Request for Additional Information No. 337, Supplement 17

U.S. EPR Standard Design Certification

Docket No. 52-020

Question 09.01.04-14:

Figure 09.01.04-14-1—Permanent RPV Refueling Cavity Ring – General Configuration

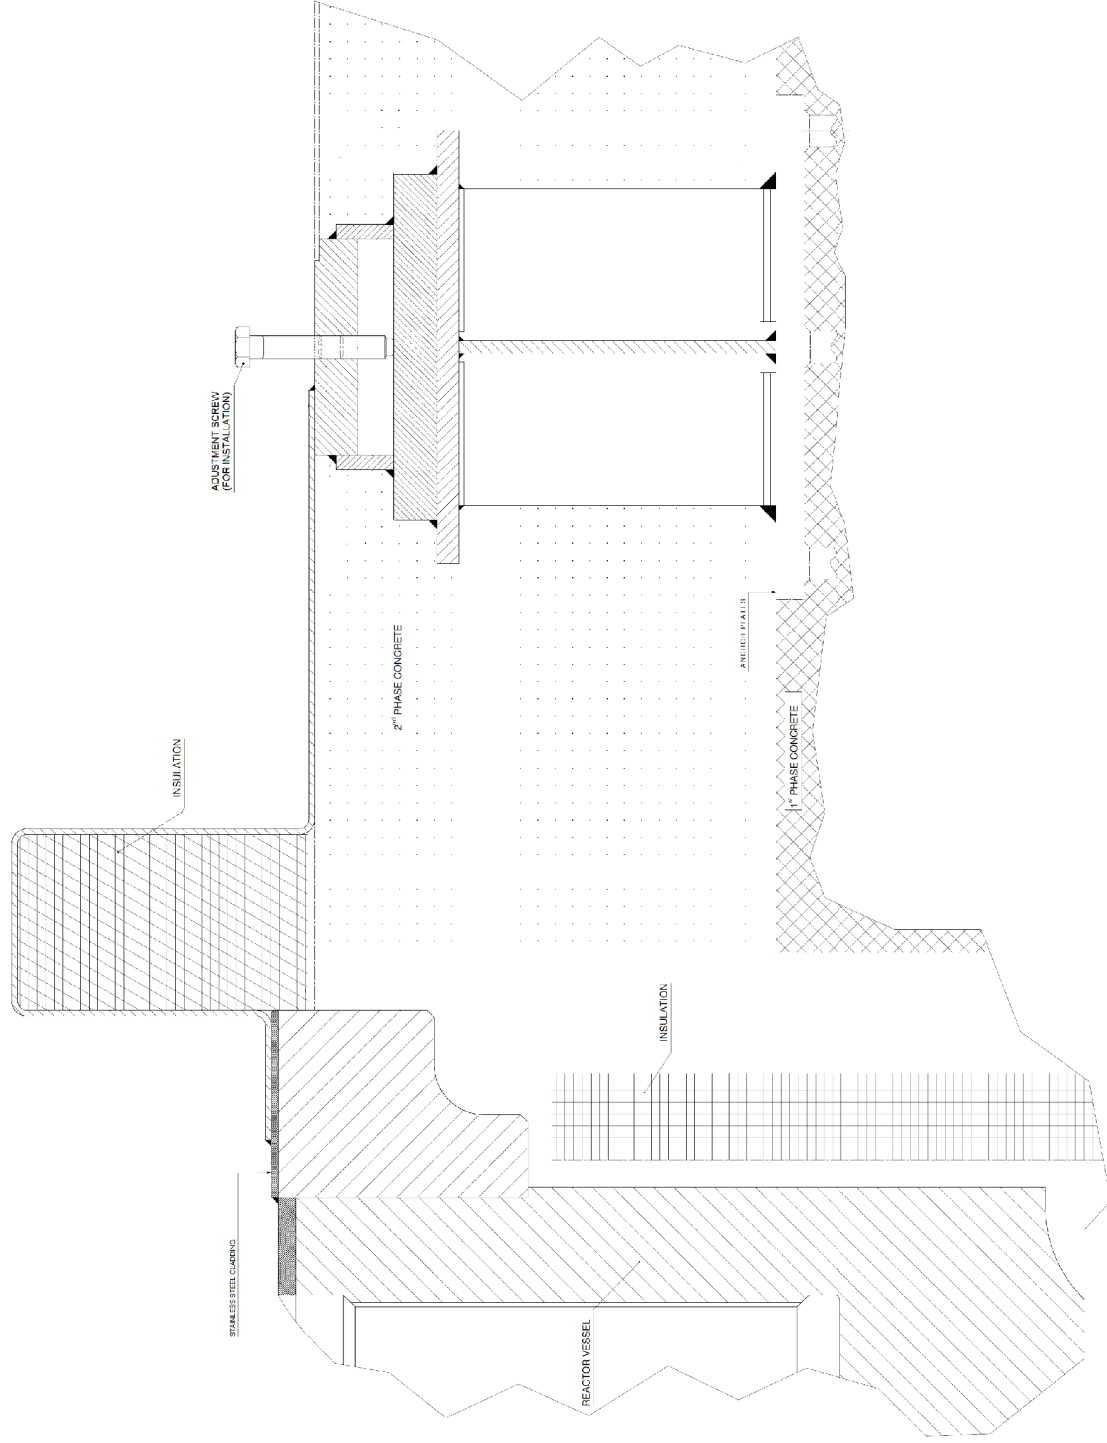
- a. Describe the design and installation of the refueling cavity seal and any other seals that will be used and whose failure could cause the refueling cavity to drain.

- b. For each of the seals identified in (a), describe measures that will be implemented to ensure that the seals remain intact and do not become degraded over time.

- c. For each of the seals identified in (a), evaluate the potential for and consequences of seal failure. These evaluations should address the following considerations:

shows the reactor cavity ring arrangement. The design is consistent with the criteria described in this response.

The RV cavity ring is designed for 60 years of plant operation. Welds that contribute to leaktightness or that perform a structural function necessary to maintain leaktightness are accessible for inspection before filling the refueling cavity. Significant leakage is detected in the reactor pit after filling the refueling cavity. Because the cavity ring does not rely on seals, leakage is only possible from a through wall defect.

1. Potential reactor cavity ring failure modes include weld failures resulting from cyclic loadings, seismic events, or fuel assembly drops. The cavity ring is designed for anticipated cyclic thermal and hydrostatic loads during plant operation, and weld failure is not expected. Based on the arrangement and weld locations in Figure 09.01.04-14-1, even if a weld cracked, catastrophic failure of the cavity ring as a fluid barrier between the refueling cavity and reactor pit is not possible. The cavity ring is designed as a Seismic Category I component so that it retains its leaktight function during and following an SSE. The cavity ring is also designed for the dropped fuel assembly impact with resultant leakage less than the capacity of the makeup flow to the refueling cavity. Makeup flow using a fuel pool purification system pump is 400 gpm.
